Shire of Wyndham – East Kimberley

Wyndham Boat Launching Facility

COUNCIL & COMMUNITY BRIEFING DOCUMENT

August 2020

Preliminary Option Development - Option 1: 90 deg Bays – (Similar to Current Operation)

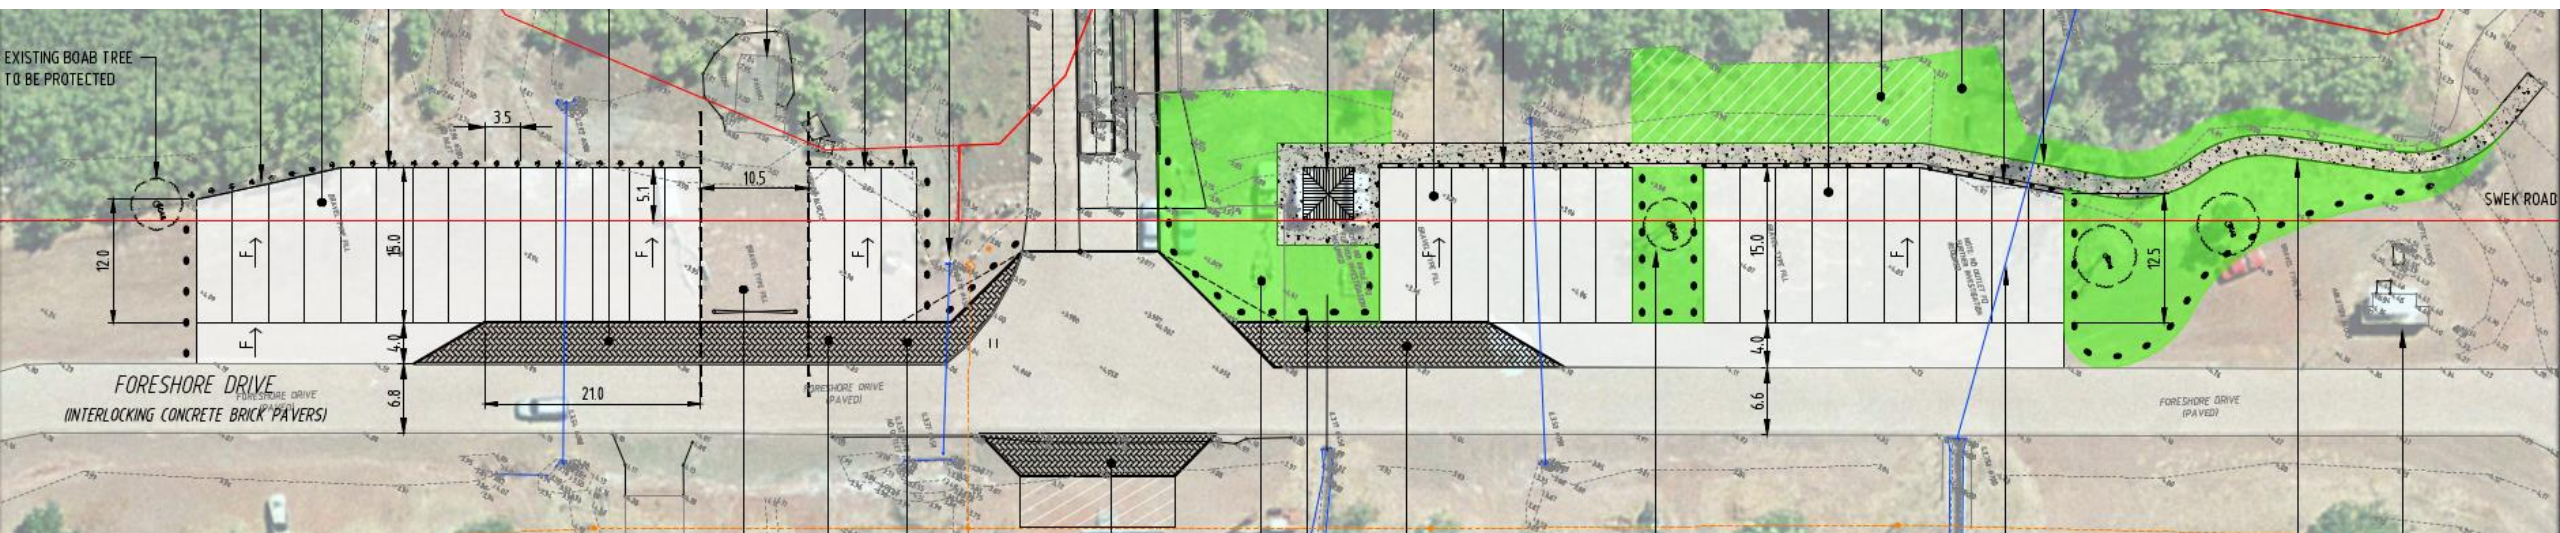
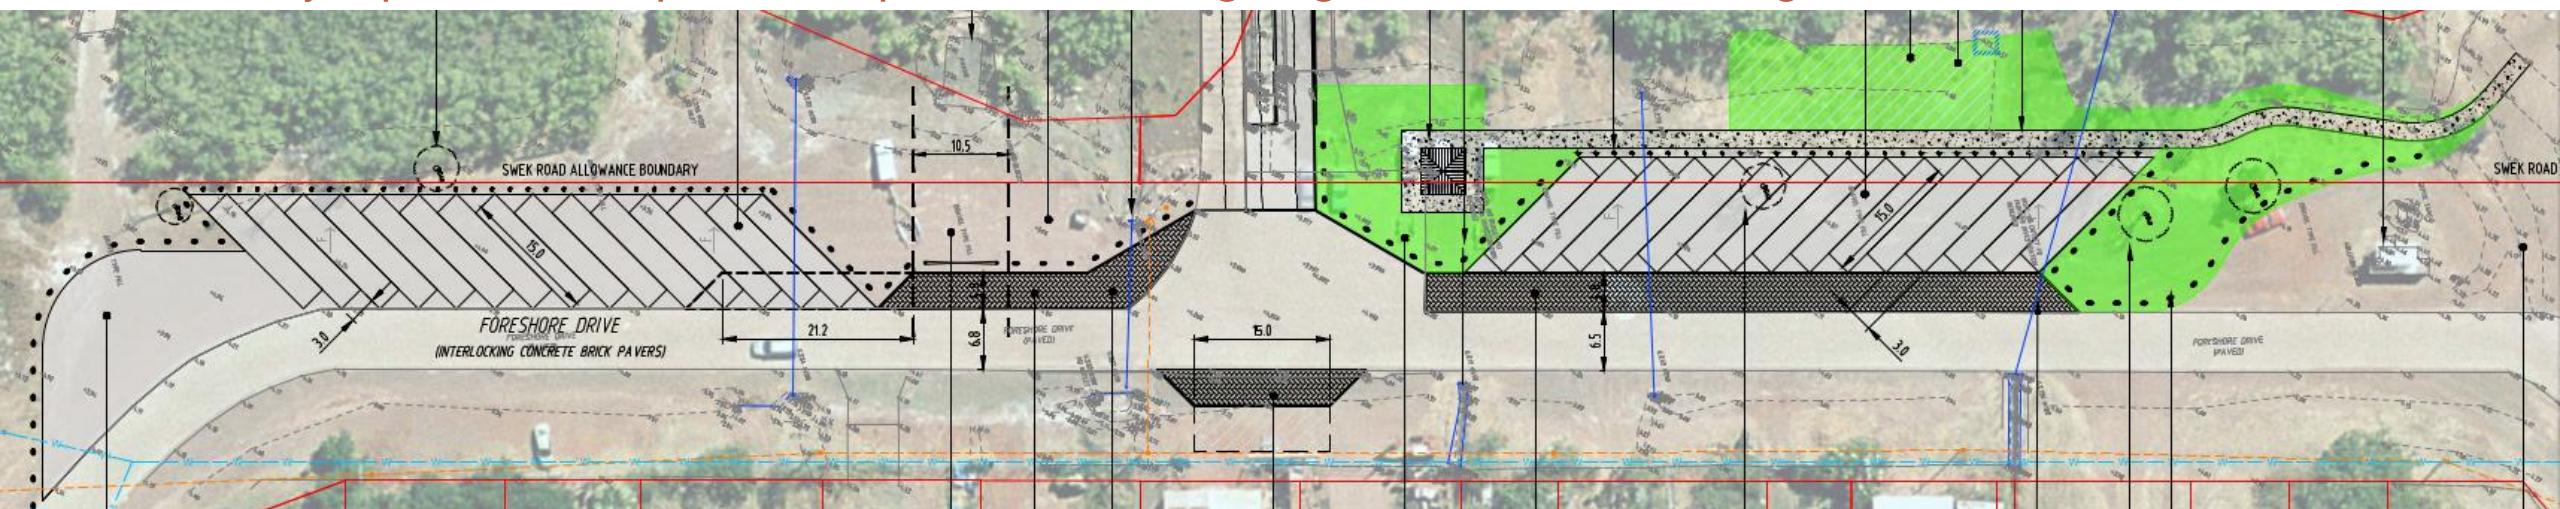
- On any given weekend there are 15-20 boats with trailers. Is there a need to create anything more than 15-20 bays, with the option to leave the southern side as an unformalised overflow parking for anything in excess of that?
- Derigging bays should be kept separate from parking bays to prevent potential accidents or traffic flow problems. May be best located south of the boat ramp.
- A footpath should be established, but should extend from Anthons Landing to the proposed ablutions at Lot 2 and linked to the DPaW sign areas.
- Could also indicate staged development for those items that will cost more or are subject to other actions occurring first, i.e. removal of ablution facilities, or any development proposed in UCL to be acquired.

Preliminary Option Development - Option 3 – “Drive Through Option”

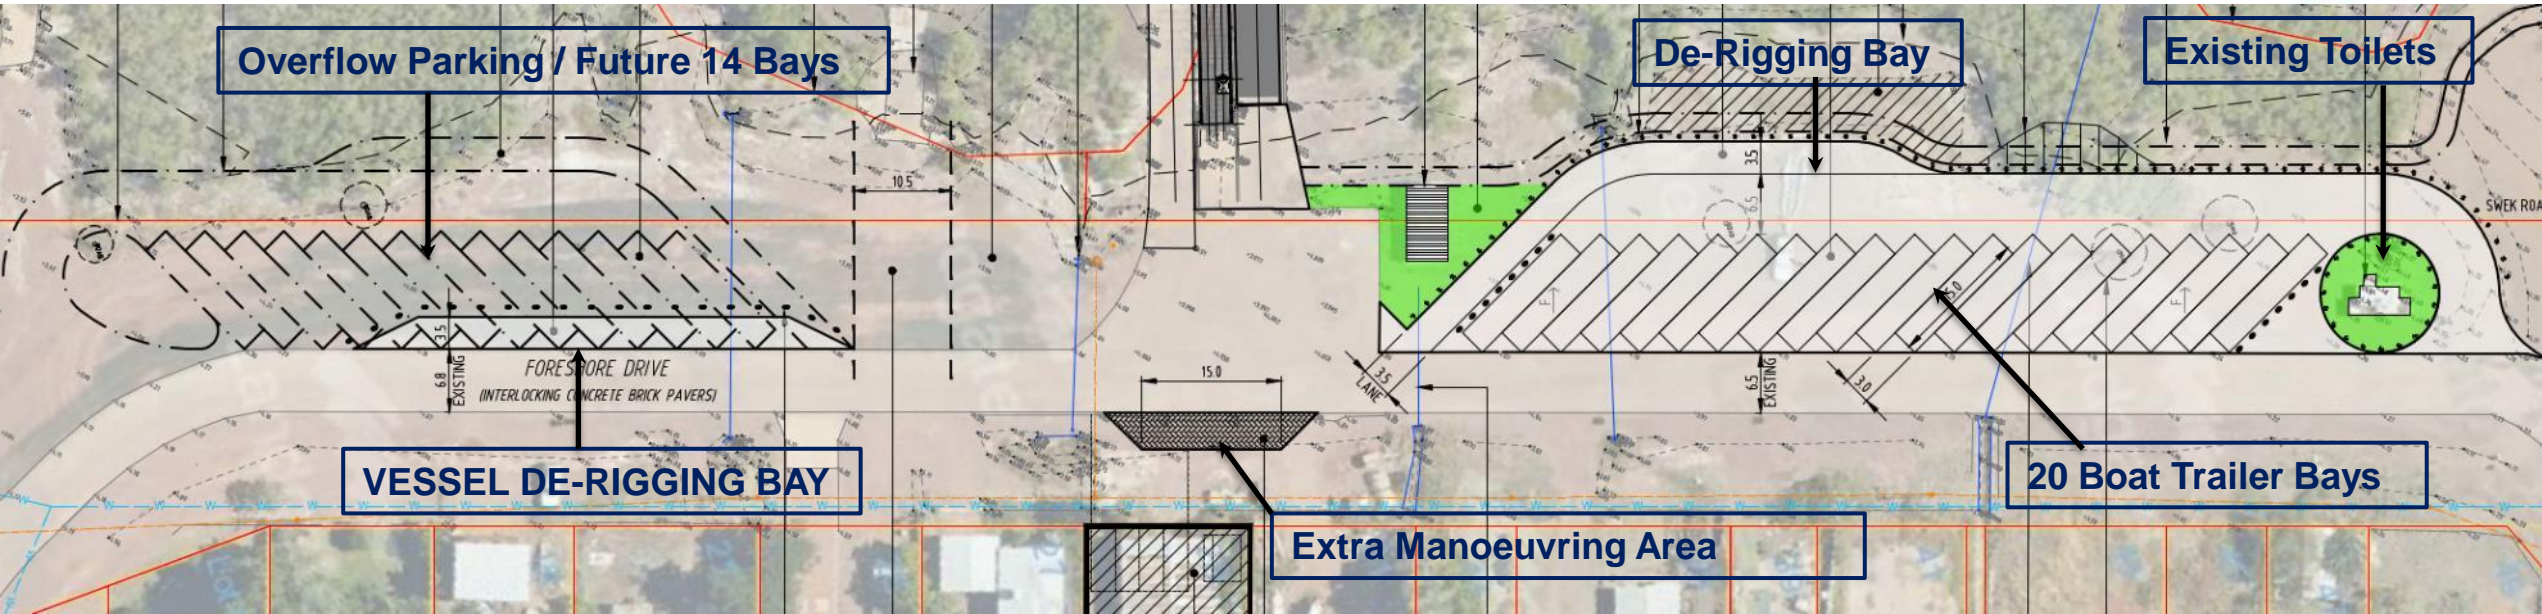
- This option is best for vehicle manoeuvrability but is the largest option in size.
- This set up allows for the de-rigging bays to be used with less interruption to those seeking to exit the parking bay, although still interrupts those looking to enter a bay.
